Access Compliance Report

Public Rights-of-Way

(Curb Ramps)

Intersection ID: 10025341	Main Street: E_7TH_ST	Cross Street: N/A	Location: N
ADA ID: CD98FF6C7387	Ramp Type: Perp	Initial Pass/Fail: Pass	Overall Compliance: No
Severity Score: 2.75			
Codes/Mitigation Info/Possible Solution		Field Measurements/Component Compliance

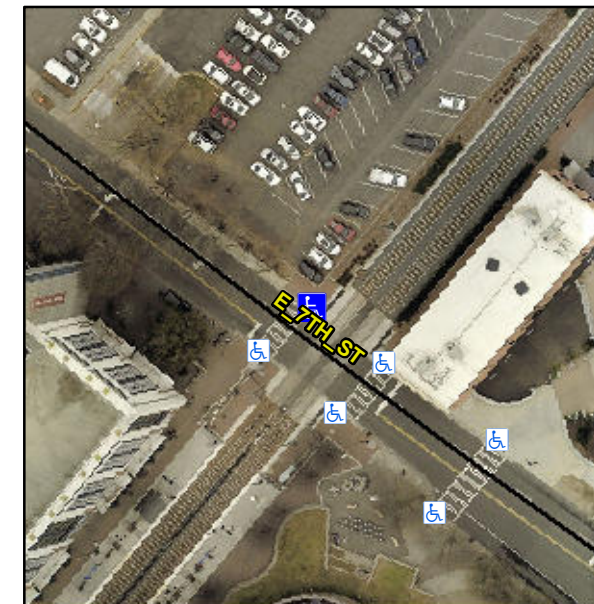
R304.2.1, R304.5.3, R304.2.3

Compliance	Description	Data	Compliance	Description	Data
N/A	Ramp Length (in)	70.0	Yes	Ramp Slope (%)	6.2
Yes	Ramp Width (in)	48.0	Yes	Ramp XSlope (%)	3.4
N/A	Flare Type LT	Sloped	N/A	Flare Type RT	N/A
N/A	Flare Slope LT (%)	11.6	Yes	Flare Slope RT (%)	4.4
N/A	Flare Traversable LT?	Yes	N/A	Flare Traversable RT?	Yes
No	Landing Length (in)	48.0	Yes	DWS Provided?	Yes
Yes	Landing Width (in)	48.0	Yes	DWS Contrast?	Yes
Yes	Landing Slope (%)	1.6	Yes	DWS Length (in)	24.0
No	Landing X Slope (%)	4.6	Yes	DWS Full Width?	Yes
N/A	Landing Curb? (Y/N)	Yes	Yes	DWS Offset (in)	0.0
N/A	Shared Landing?	No			
Yes	Gutter Ponding?	No	Yes	Gutter Slope (%)	2.9
Yes	Gutter Lip Ht (in)	0.0	Yes	Gutter X Slope (%)	2.9
N/A	Painted X Walk1?	Yes	N/A	Painted X Walk2?	N/A
	X Walk 1 Direction	To SW		X Walk 2 Direction	N/A
N/A	X Walk 1 Width (in)	112.0	N/A	X Walk 2 Width (in)	N/A
	X Walk 1 Slope (%)	1.0		X Walk 2 Slope (%)	N/A
	X Walk 1 X Slope (%)	4.1		X Walk 2 X Slope (%)	N/A

Remove & Replace Entire Ramp.
